Amended Drawing of Blr N°1012
showing additional tubes
to be fitted.

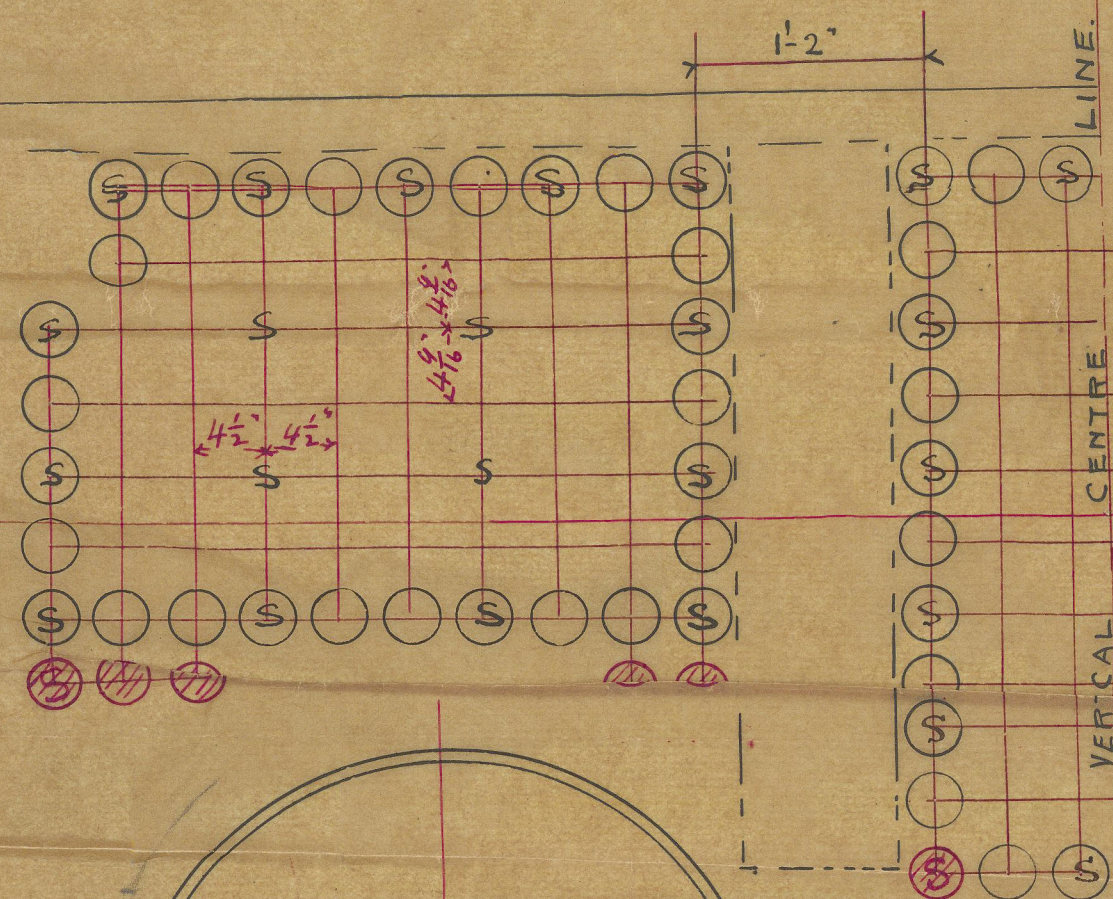
Solid Wing Stay
now taken out.

12 additional tubes to be fitted
6 on each side of Vert Centre line as shown in Red

Amended H.S. 1540 of total
